UNITED STATES
NUCLEAR REGULATORY COMMISSION
WASHINGTON, D. C. 20555

SEQUOYAH NUCLEAR PLANT, UNIT 1

AMENDMENT TO FACILITY OPERATING LICENSE

Amendment No. 158
License No. DPR-77

FIGURE 3.4-2 SEDUOYAH UNIT 1 REACTOR COOLANT SYSTEM HEATUP LIMITATIONS
 APPLICABLE UP TO 16 EFPY

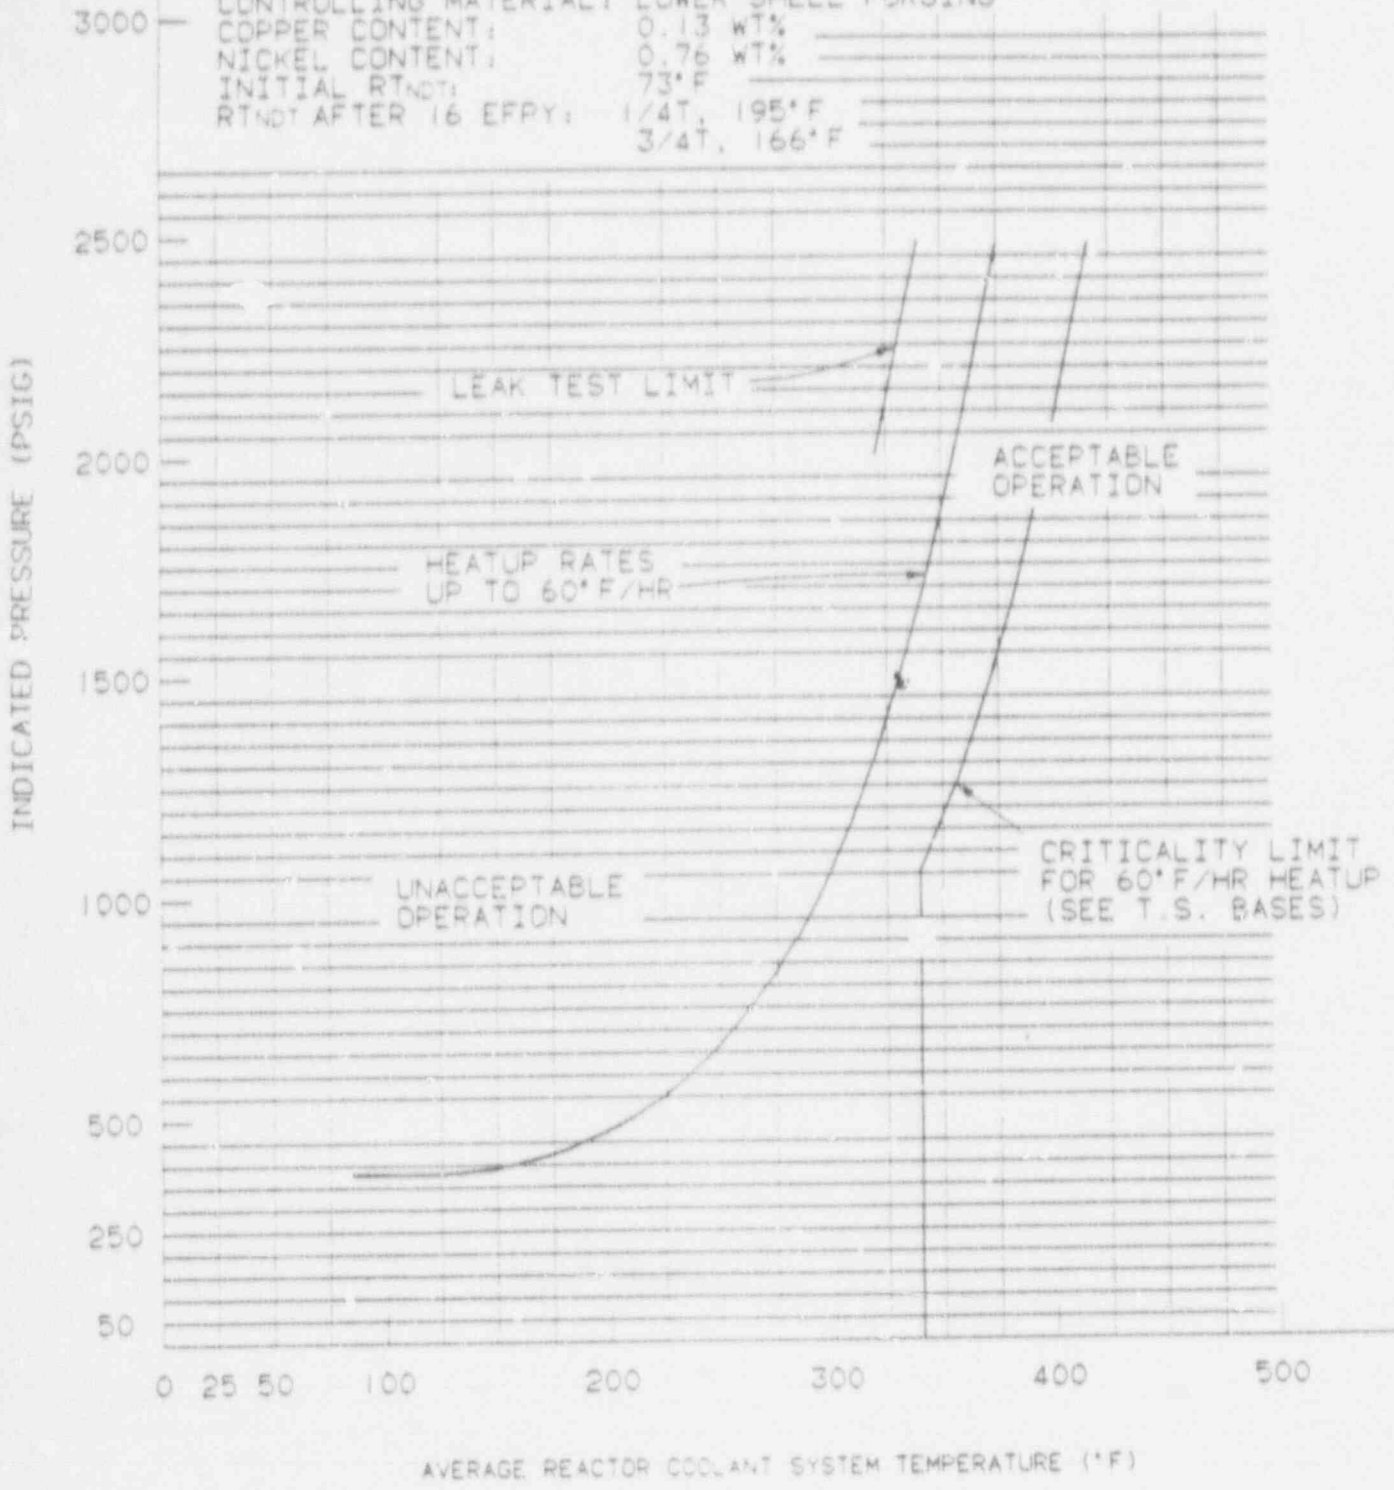
CURVES APPLICABLE FOR HEATUP RATES UP TO 60°F/HR
 FOR THE SERVICE PERIOD UP TO 16 EFPY, MARGINS OF 60 PSIG
 AND 10°F ARE INCLUDED FOR POSSIBLE INSTRUMENT ERROR.

MATERIAL PROPERTY BASIS - SO₂ UNIT 1
 CONTROLLING MATERIAL: LOWER SHELL FORGING
 COPPER CONTENT: 0.13 WT%
 NICKEL CONTENT: 0.76 WT%
 INITIAL RTNDT: 73°F
 RTNDT AFTER 16 EFPY: 1/4T, 195°F
 3/4T, 166°F

FIGURE 3.4-3 SEQUOYAH UNIT 1 REACTOR COOLANT SYSTEM COOLDOWN LIMITATIONS APPLICABLE UP TO 16 EFPY

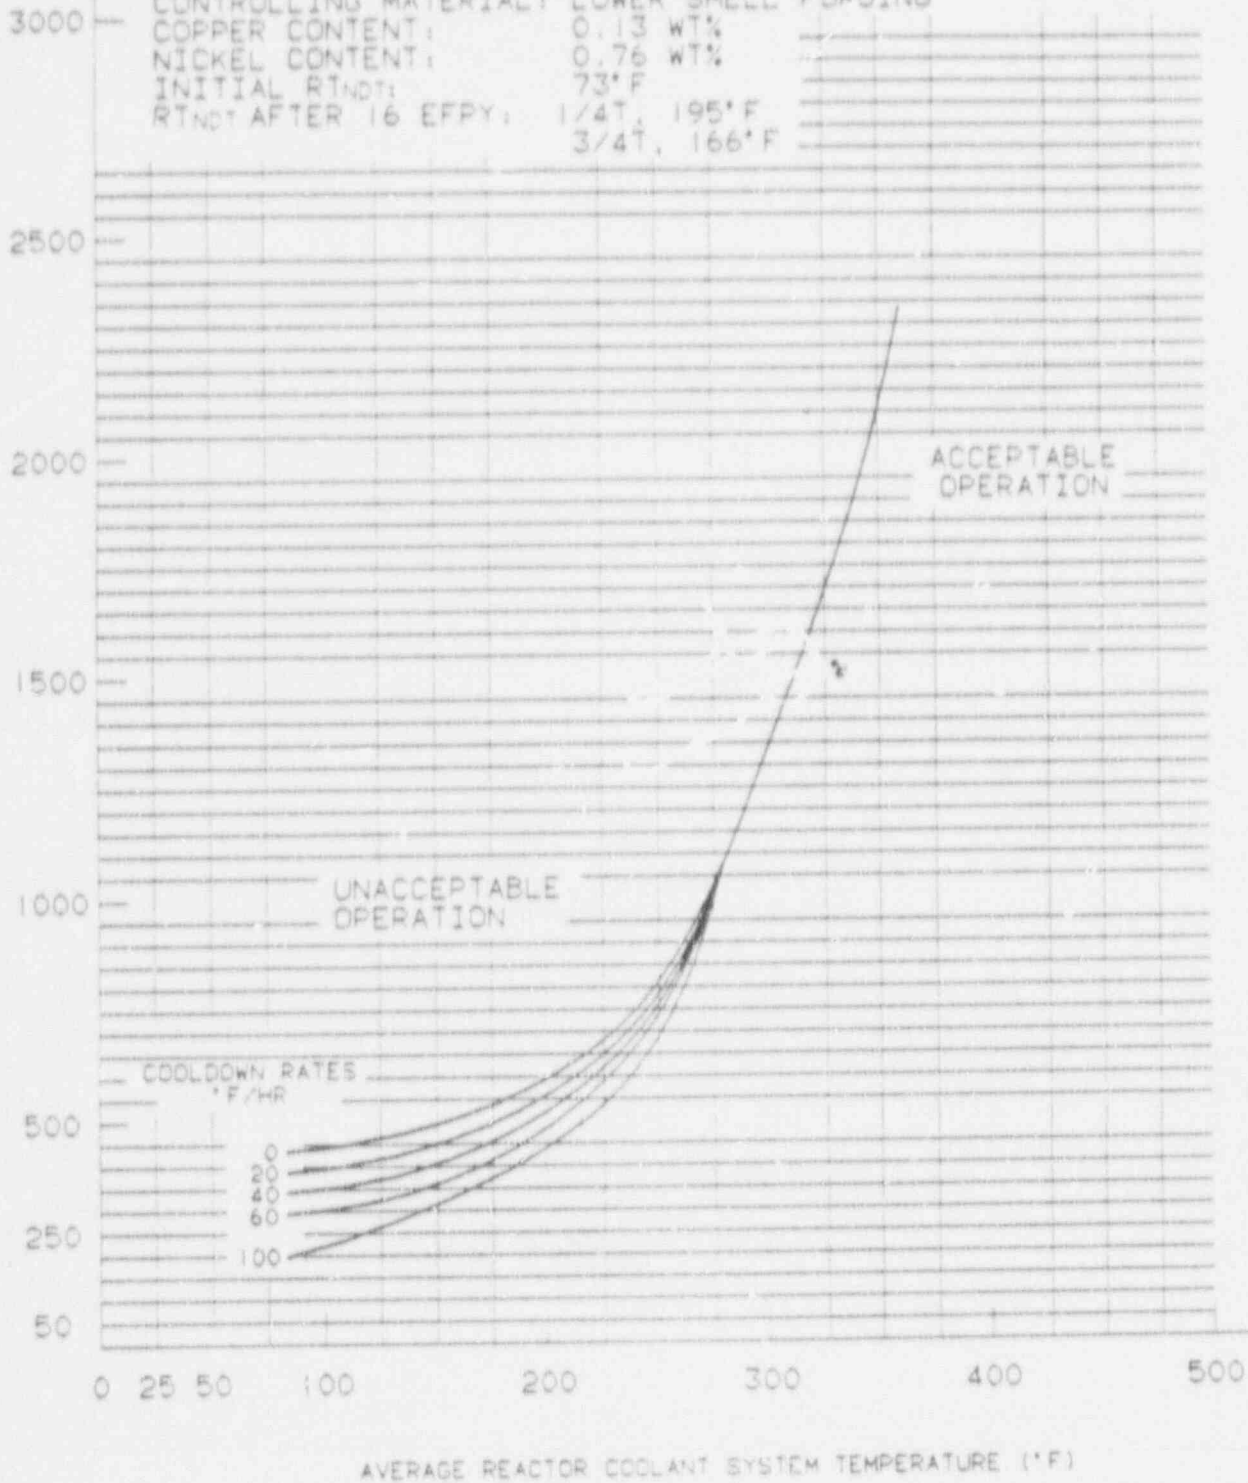
CURVES APPLICABLE FOR COOLDOWN RATES UP TO 100°F/HR FOR THE SERVICE PERIOD UP TO 16 EFPY. MARGINS OF 60 PSIG AND 10°F ARE INCLUDED FOR POSSIBLE INSTRUMENT ERROR.

CONTROLLING MATERIAL: LOWER SHELL FORGING

COPPER CONTENT: 0.13 WT%

NICKEL CONTENT: 0.76 WT%

INITIAL RTNDT: 73°F

RTNDT AFTER 16 EFPY: 1/4T, 195°F
3/4T, 166°F

FIGURE 3.4-2 SEQUOYAH UNIT 2 REACTOR COOLANT SYSTEM HEATUP LIMITATIONS APPLICABLE UP TO 16 EFPY.

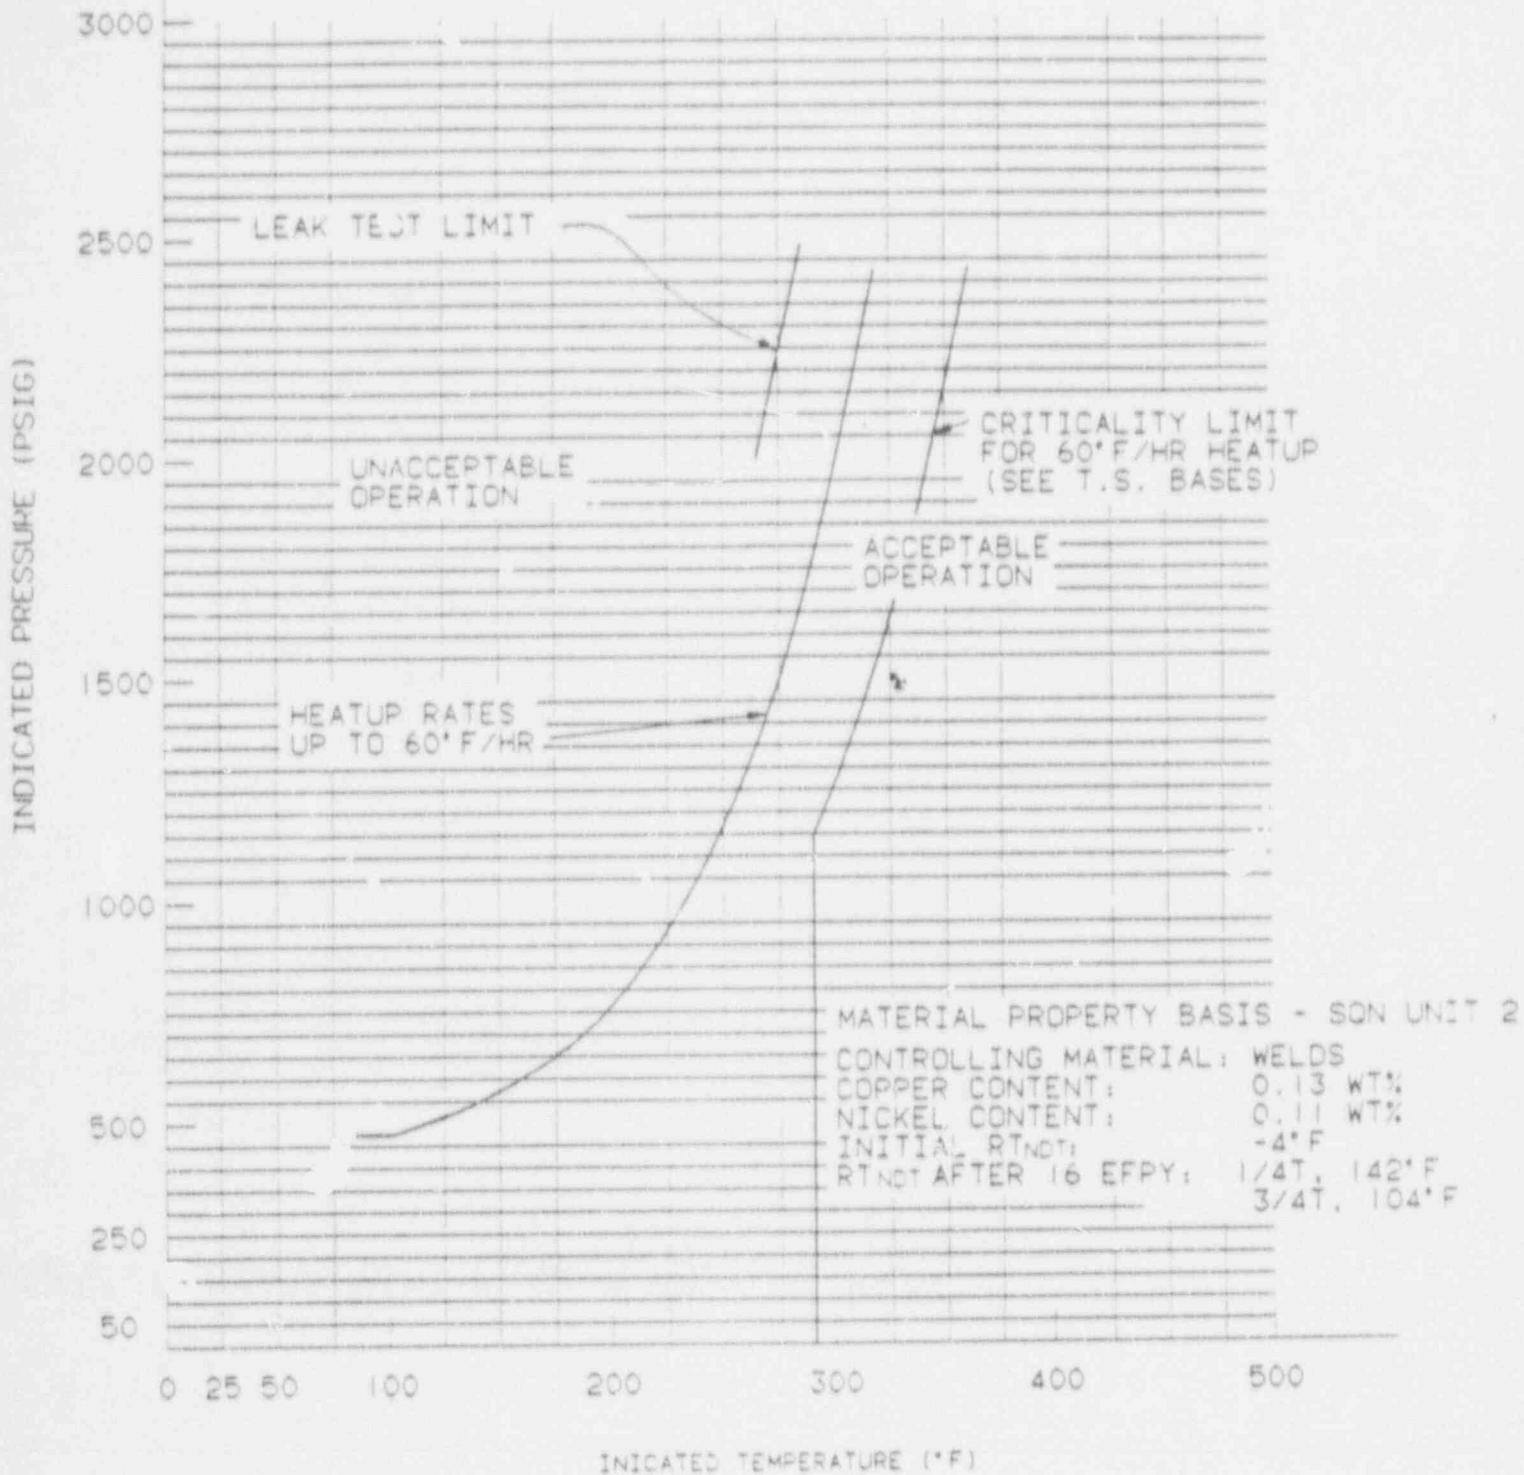
CURVES APPLICABLE FOR HEATUP RATES UP TO 60°F/HR FOR THE SERVICE PERIOD UP TO 16 EFPY. MARGINS OF 60 PSIG AND 10°F ARE INCLUDED FOR POSSIBLE INSTRUMENT ERRORS.

FIGURE 3.4-3 SEQUOYAH UNIT 2 REACTOR COOLANT SYSTEM COOLDOWN LIMITATIONS APPLICABLE UP TO 16 EFPY

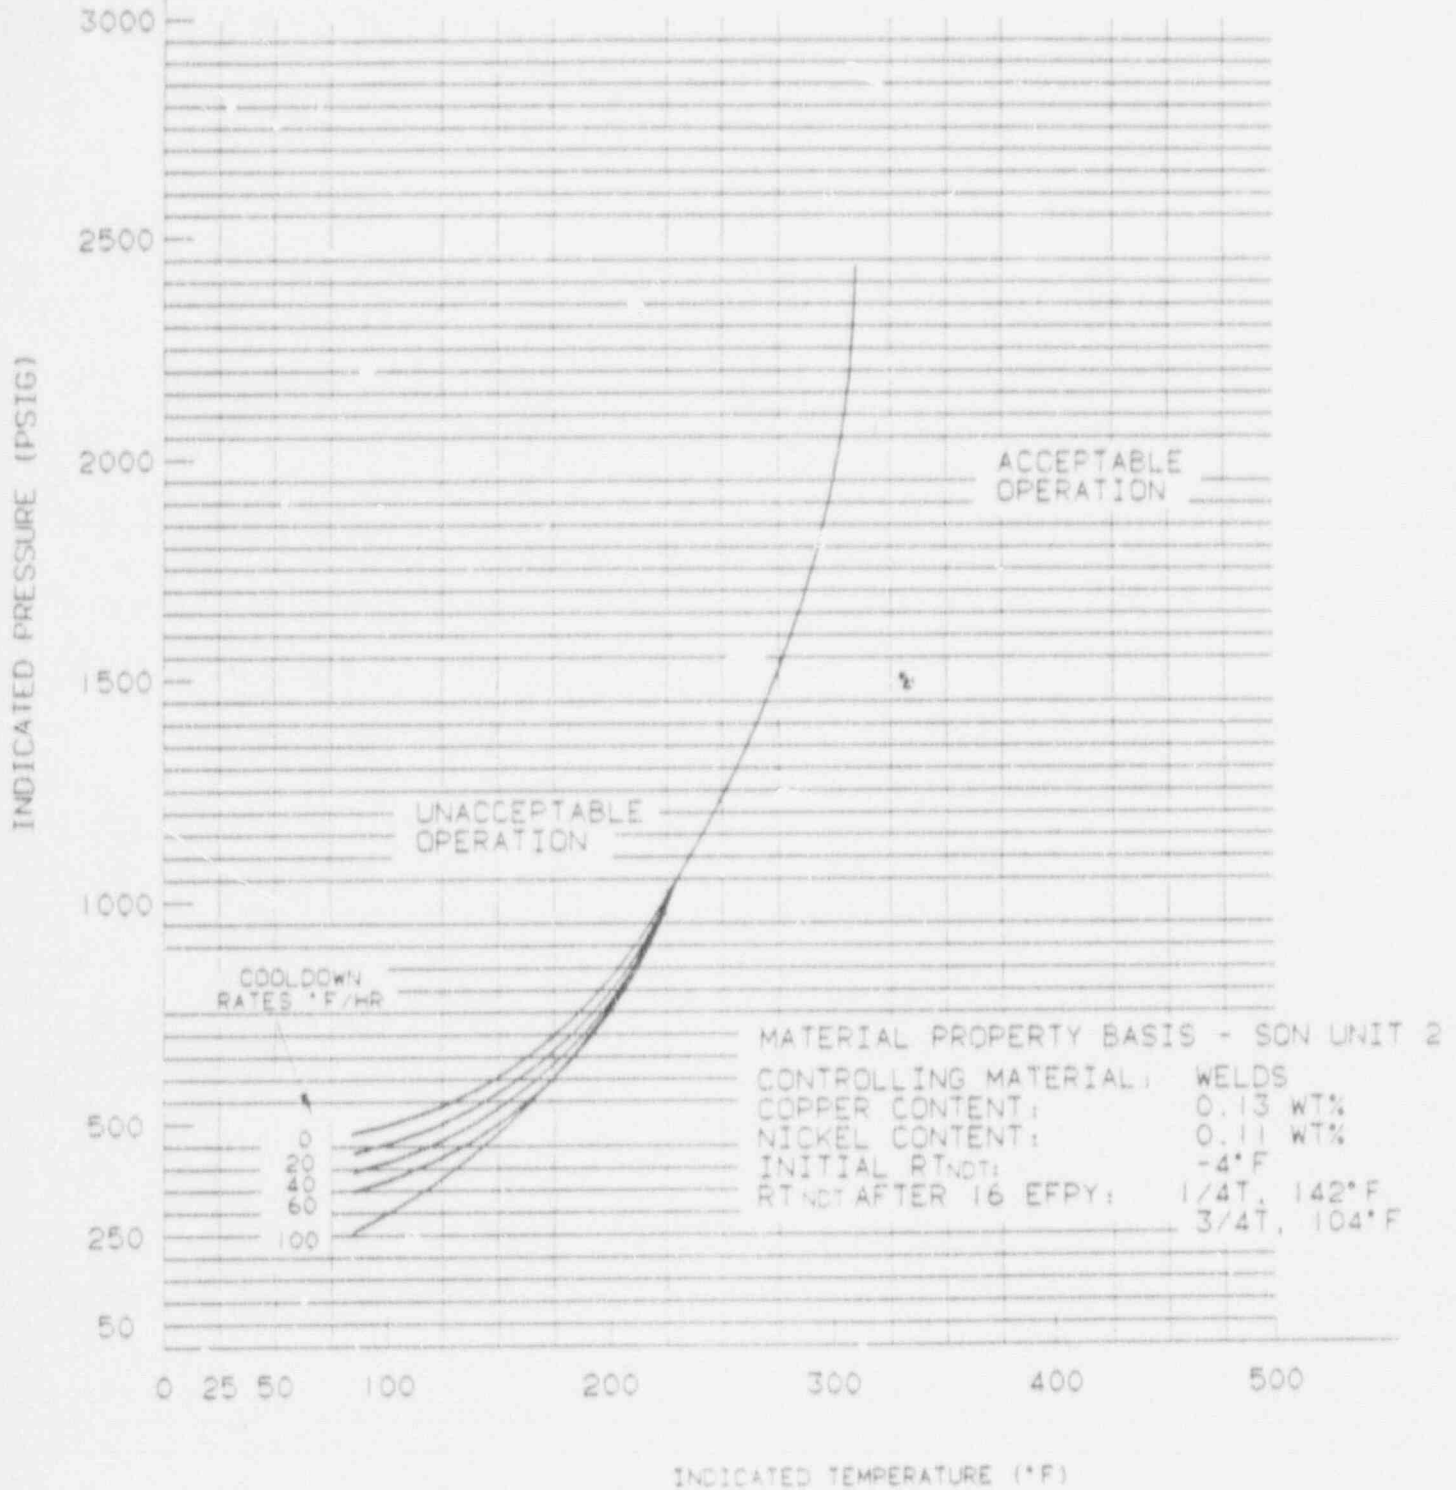
CURVES APPLICABLE FOR COOLDOWN RATES UP TO 100°F/HR FOR THE SERVICE PERIOD UP TO 16 EFPY. MARGINS OF 60 PSIG AND 10°F ARE INCLUDED FOR POSSIBLE INSTRUMENT ERRORS.
